Docket 50-305  
Operating License DPR-43  
Kewaunee Nuclear Power Plant  
Response to NRC Request For Additional Information Concerning Leak  
Before Break Analysis For Kewaunee Nuclear Power Plant

**Nuclear Management Company, LLC Response to NRC's Request for Additional Information Regarding Request to Exclude Dynamic Effects Associated with Postulated Pipe Ruptures From Licensing Basis for Residual Heat Removal, Accumulator Injection, and Safety Injection System Piping Based Upon Leak Before Break Analysis.**

**Leak-Before-Break Evaluation  
6-inch to 12-inch Safety Injection and  
Residual Heat Removal Piping Attached to the RCS  
Kewaunee Nuclear Power Plant  
Revision No. 1**

Drawings Discussed in Response to NRC Questions 1 and 2

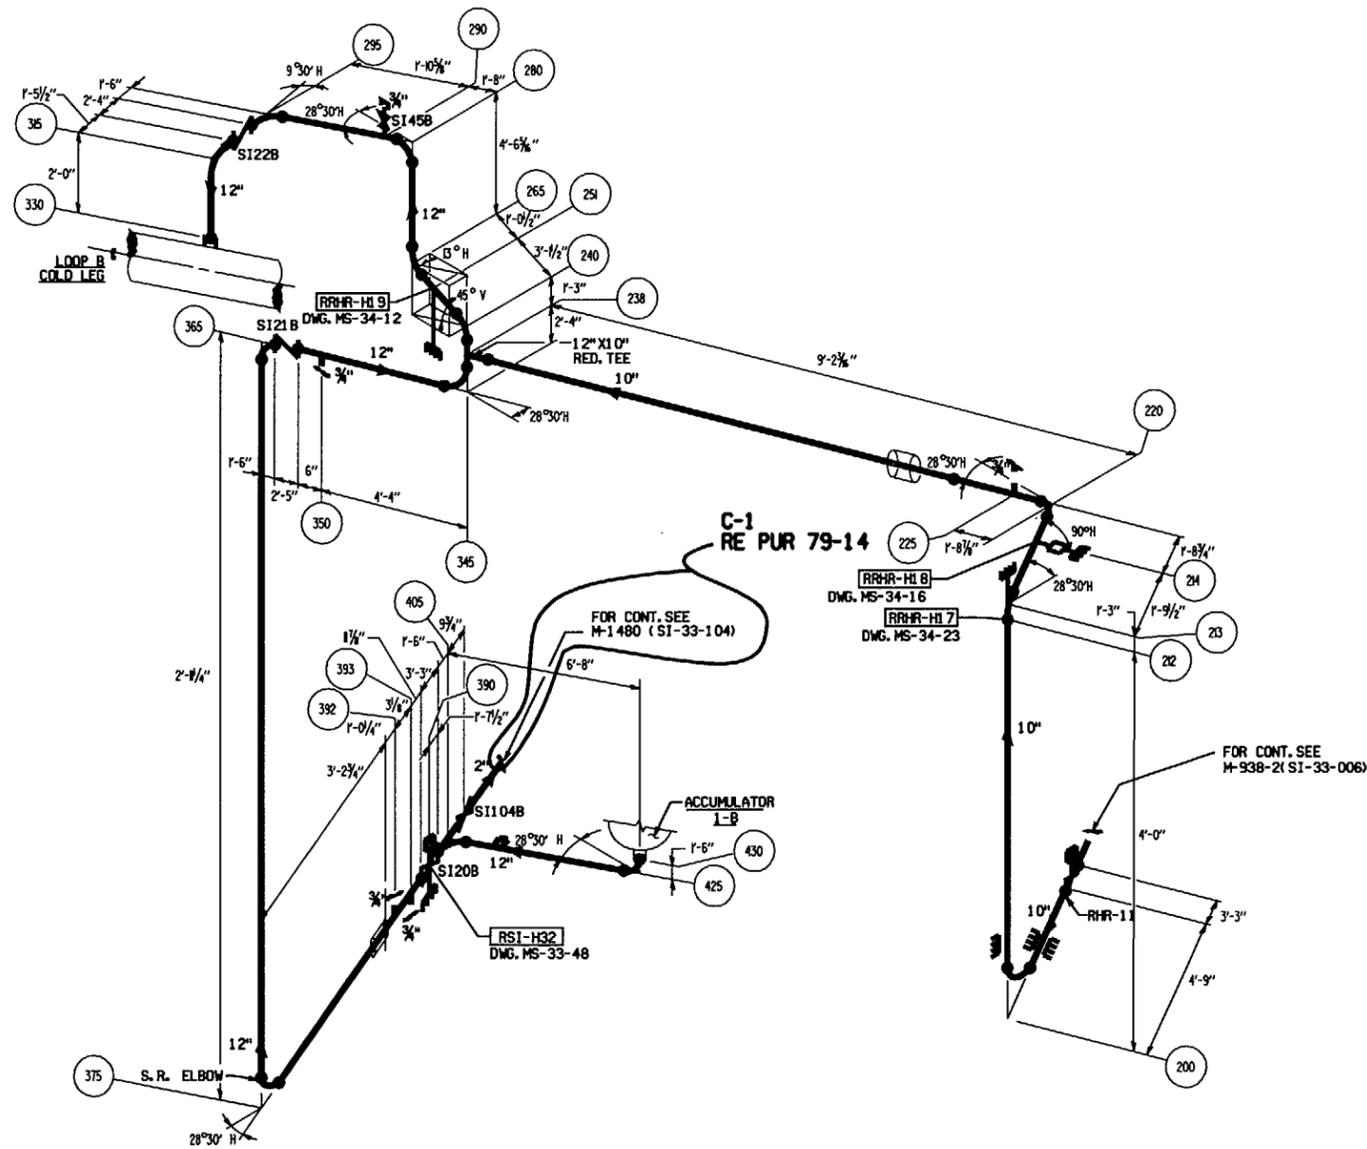
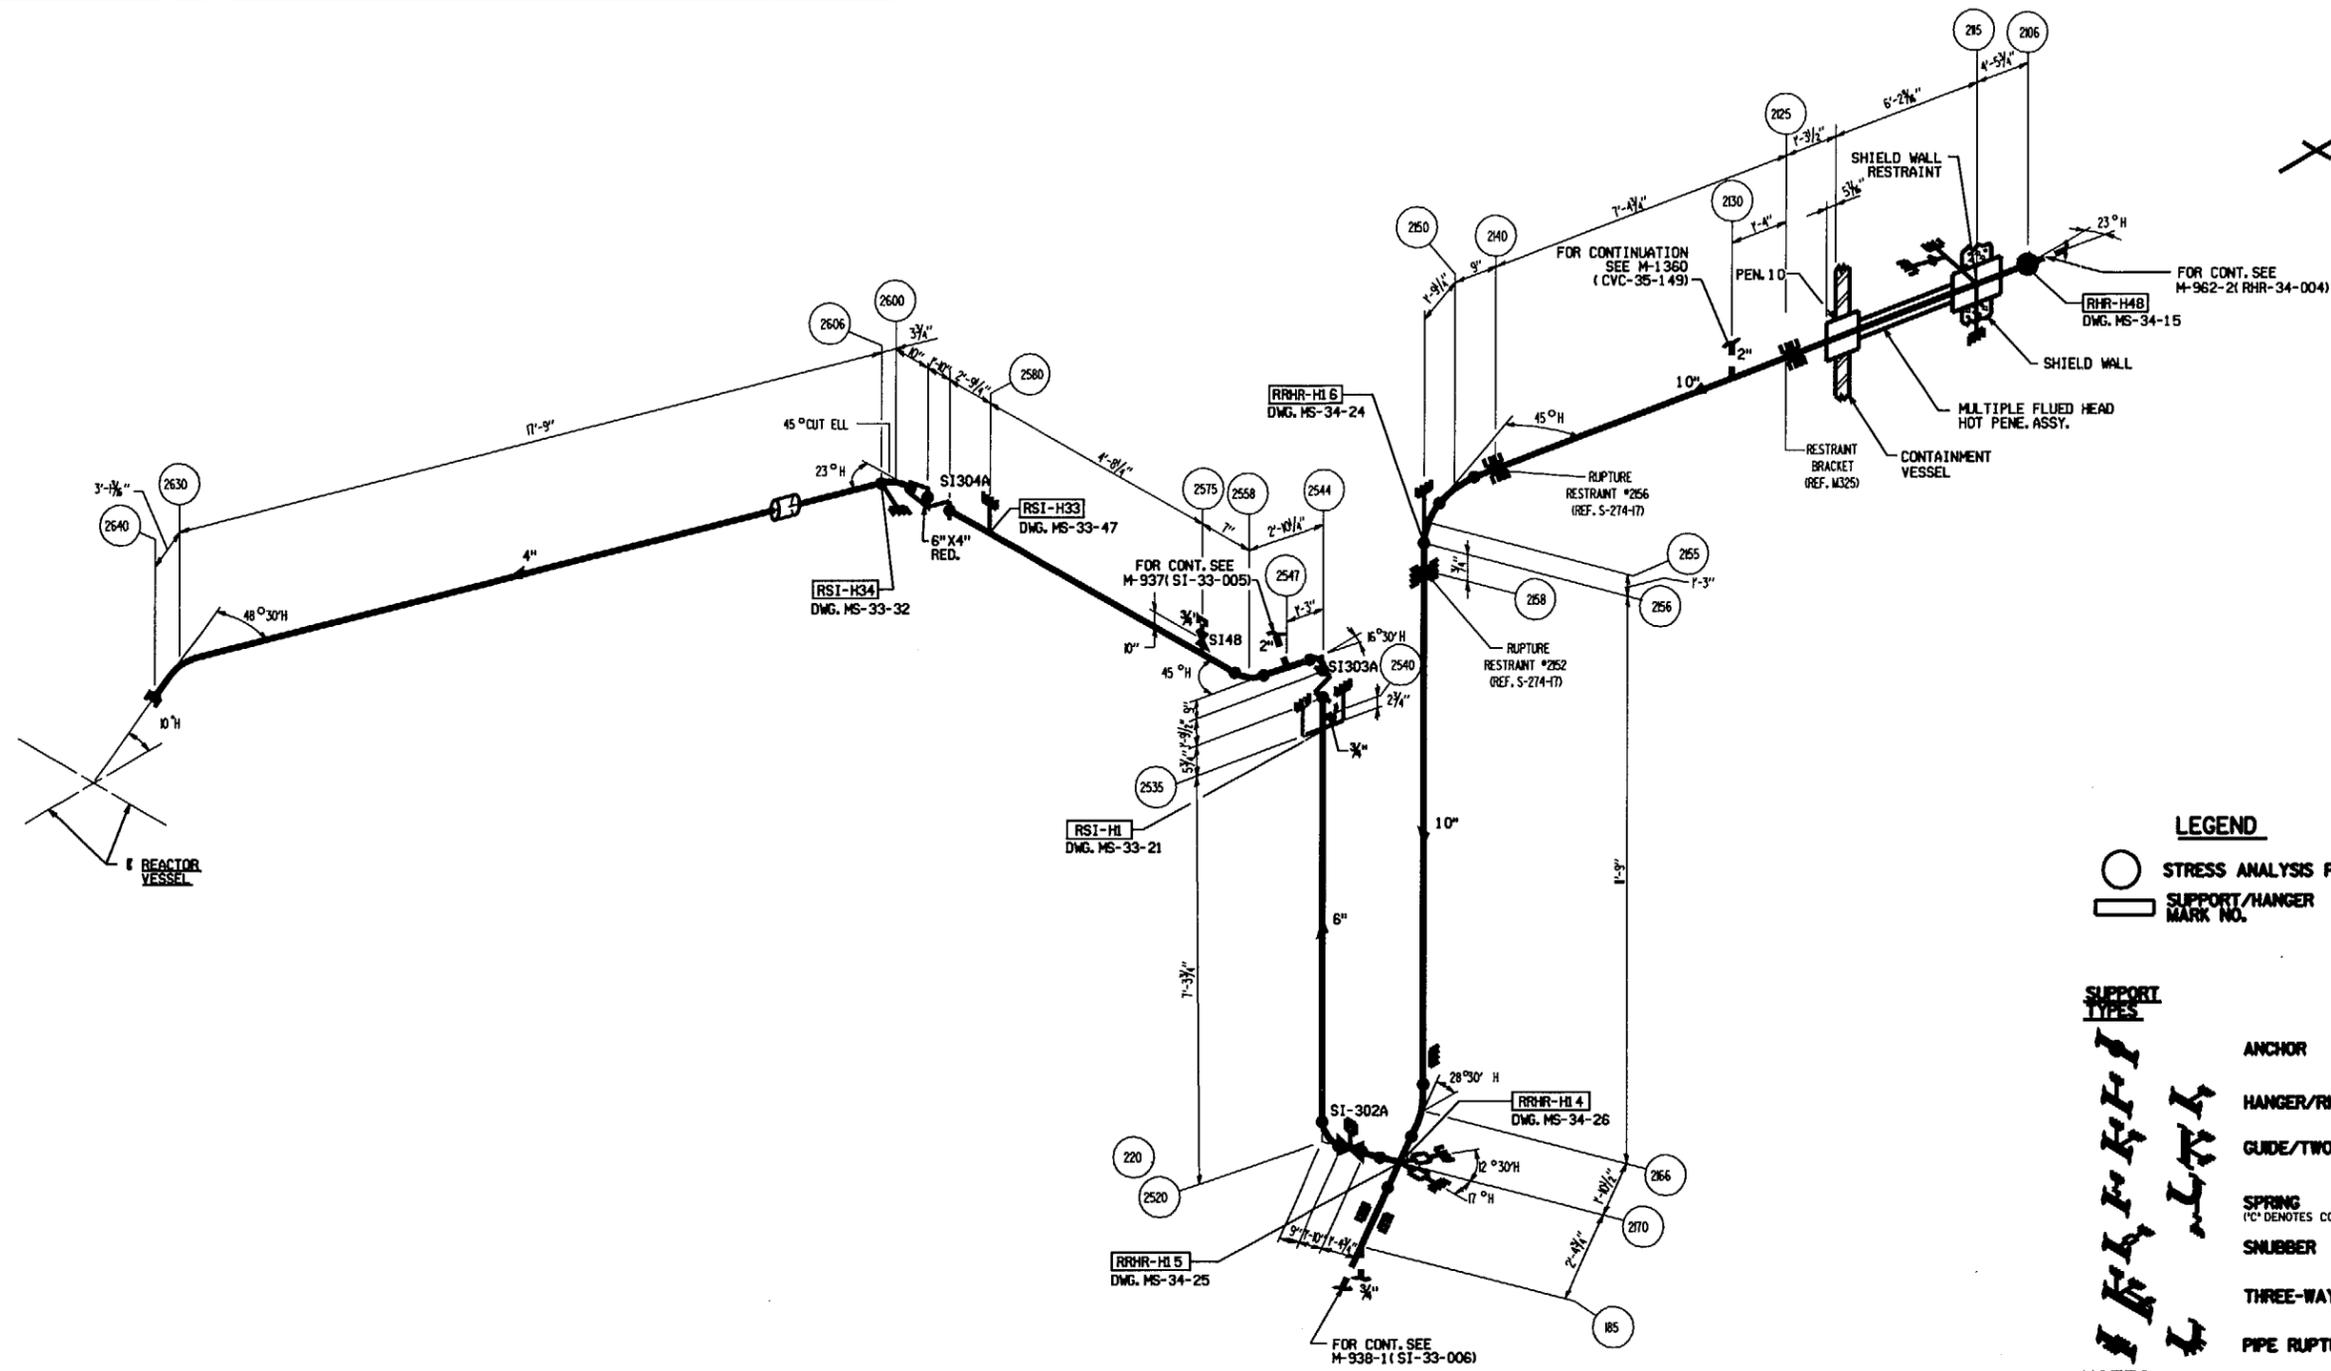
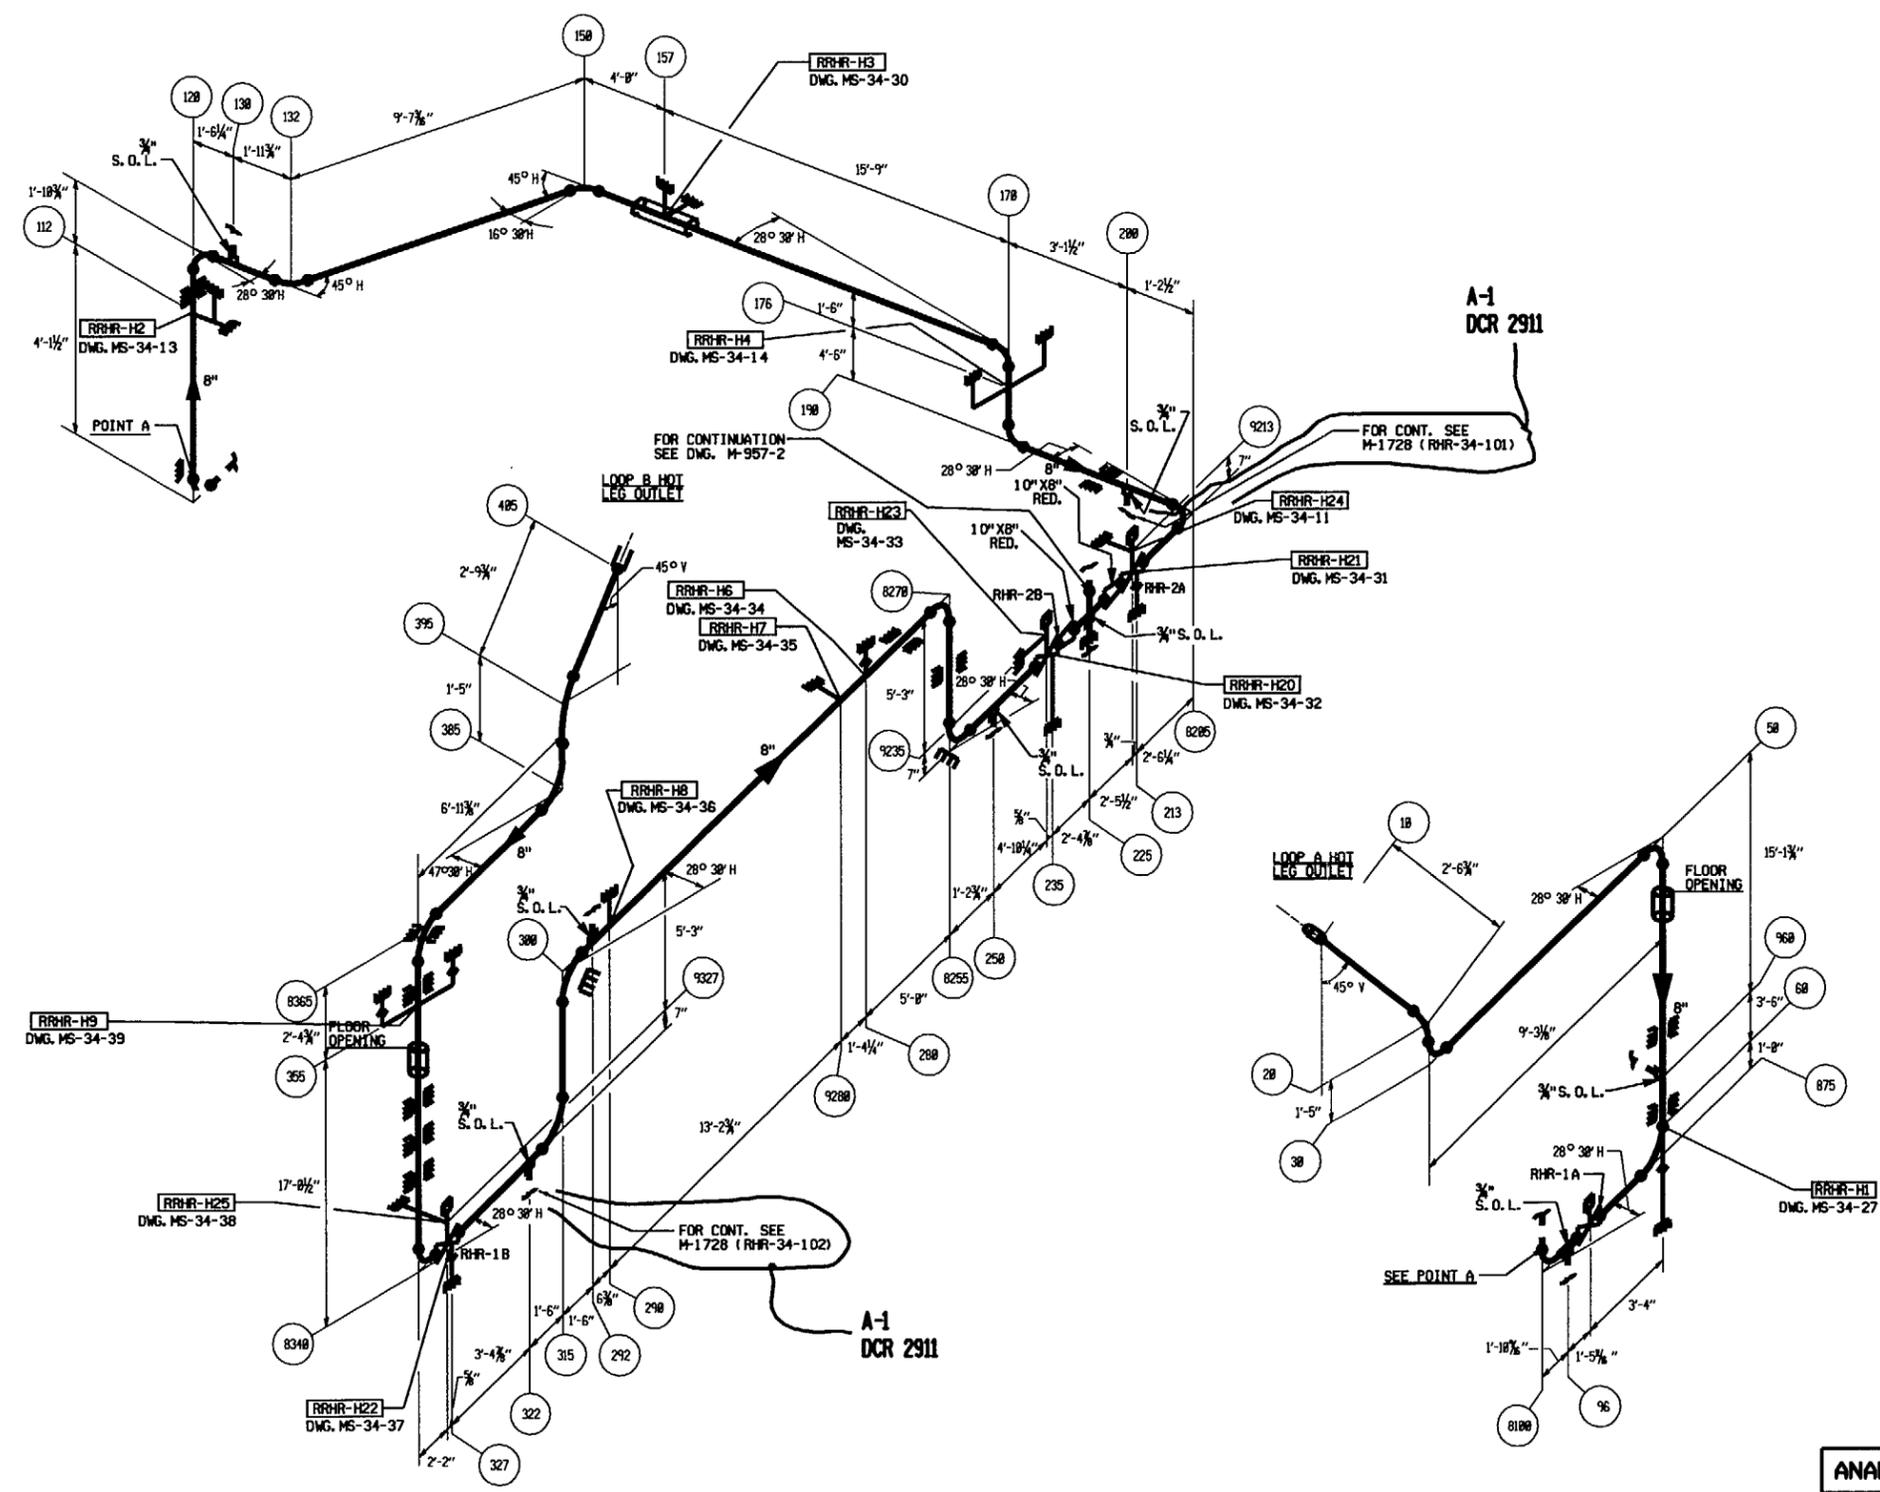
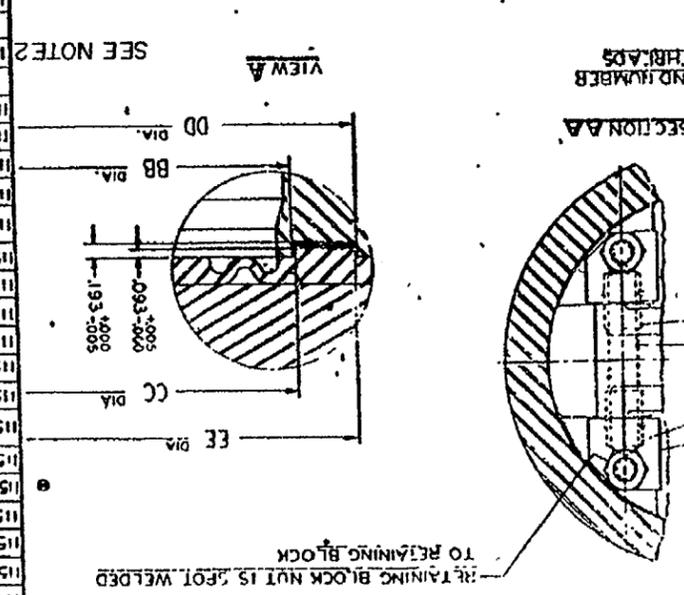
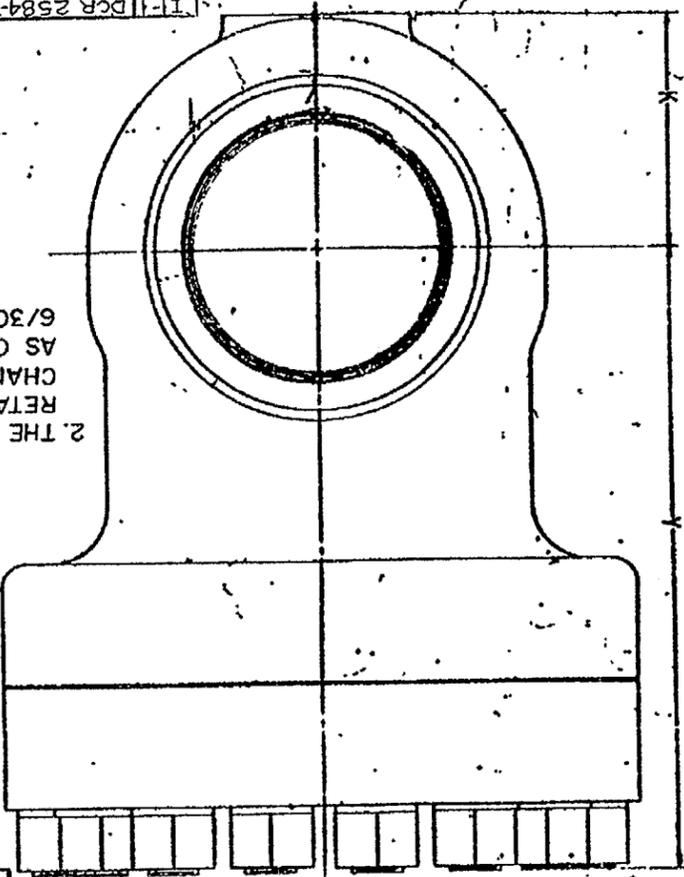
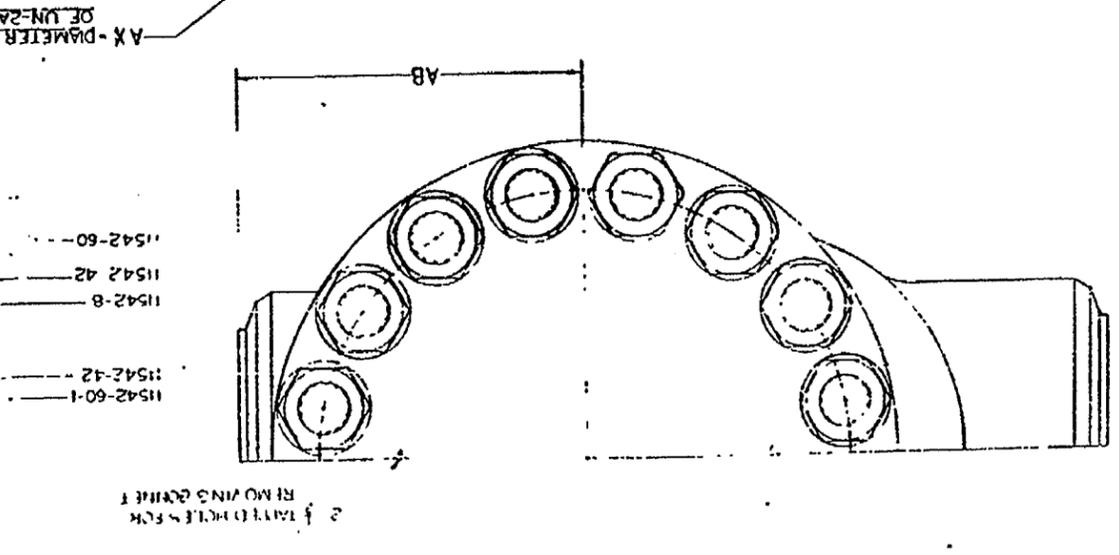
**NRC Question #1.** The cover letter to NMC's February 23, 2001, submittal states that NMC is requesting Leak-Before-Break approval for the following piping at the Kewaunee Nuclear Power Plant (KNPP), along with some description of each item:

- (1) 12-inch diameter safety injection system piping;
- (2) 8-inch diameter residual heat removal system piping;
- (3) 6-inch diameter cold leg safety injection system piping;
- (4) 6-inch diameter reactor vessel safety injection system piping.

Confirm whether or not item (4) is actually included in the KNPP submittal inasmuch as no specific tabular information in the report was identified as applying to the 6-inch diameter reactor vessel safety injection system piping. Provide piping diagrams (similar to those shown in Figures 5-7, 5-8, and 5-9 of report SIR-00-045, Rev. 0), which show the specific portions of the KNPP piping systems for which LBB approval being sought.

Tables 4-3, 4-4 and 4-5 do represent the nodal moments specific to the KNPP systems in question. For the 6-inch hot leg nozzle, there are no moments since the nozzle is capped.

There are no cast austenitic steel piping sections present in any of the analyzed portions of piping. However, two valves (SI-22A and SI-22B) that function to isolate reactor coolant fluid are fabricated from CF-8 material. These valves are part of the 12-inch diameter safety injection system piping identified under item 1 in NRC question 1. A drawing for these valves is provided in attachment 2. Since the valves are much thicker than the attachment piping and pipe-to-valve weldments, standard practice in LBB evaluations has been not to include these relatively thicker components in the LBB evaluation.
